**Quality Audit Report  
Proposed Part 8 Residential  
Development, Oldtown Mill Road,  
Celbridge, Co. Kildare**

<b>Client:</b>	Malone O'Regan Consulting Engineers
<b>Document No:</b>	231860-ORS-XX-XX-RP-TR-13g-005

This report documents the findings of a Stage 1 Road Safety Audit (RSA) carried out with respect to a Part 8 proposal for the development of 60 no. residential units at Oldtown Mill Road, Celbridge, Co. Kildare.

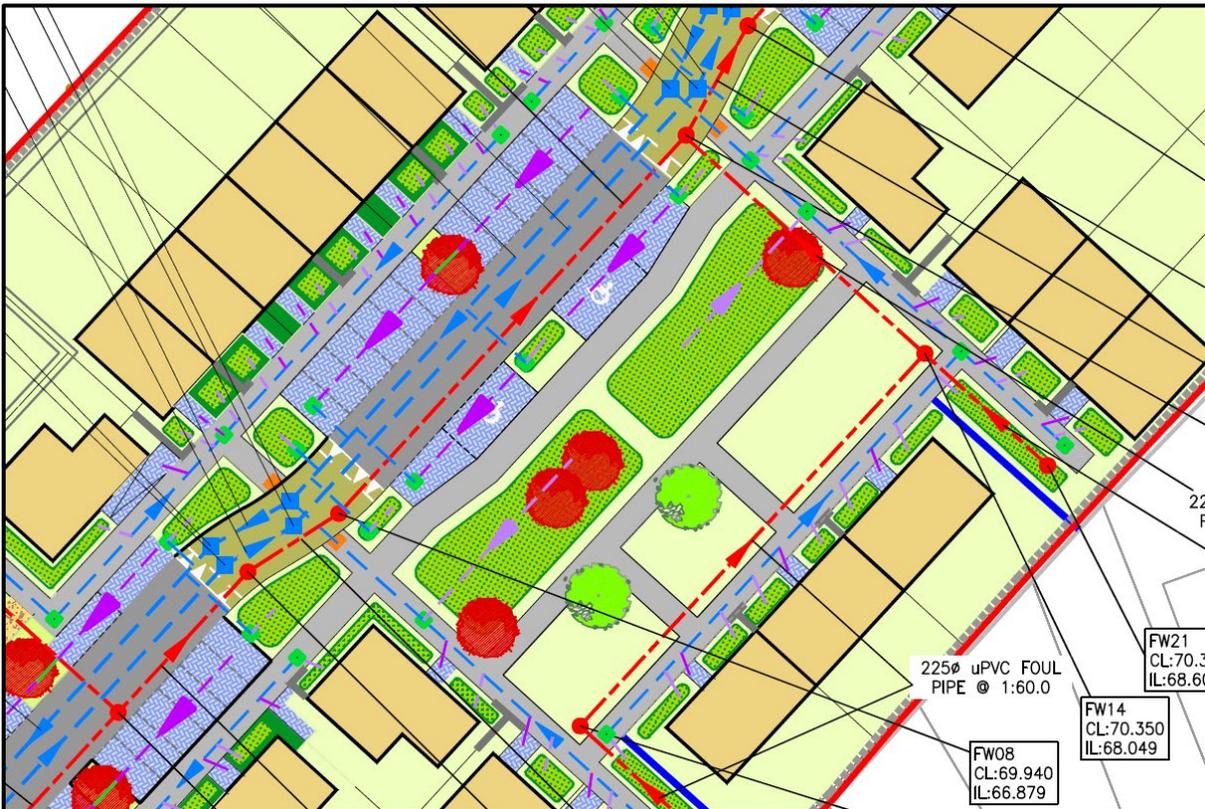
**Problem No.2: Manholes Along Pedestrian Routes**

**Location: Throughout the Site**

The audit team noted from the provided drawings that several manholes are proposed along pedestrian routes and crossing points within the project area. However, there is a concern regarding the slip resistance surfacing of these manholes which could create a trip hazard for vulnerable users particularly those with mobility or visual impairments, potentially resulting in injuries.

**Recommendation:**

The design team should ensure that all proposed manhole covers along pedestrian routes have appropriate anti-slip surfacing and are installed level with the surrounding footpath to mitigate the potential for trip and falls.

Problem Reference in Safety Audit Report	To Be Completed by the Designer			To be Completed Audit Team Leader
	Problem Accepted (Yes/No)	Recommendation Accepted (Yes/No)	Alternative Option (Describe) (Only complete if recommendation not accepted)	Alternative Option Accepted by Auditors (Yes/No)
P1	Yes	Yes		
P2	Yes	Yes
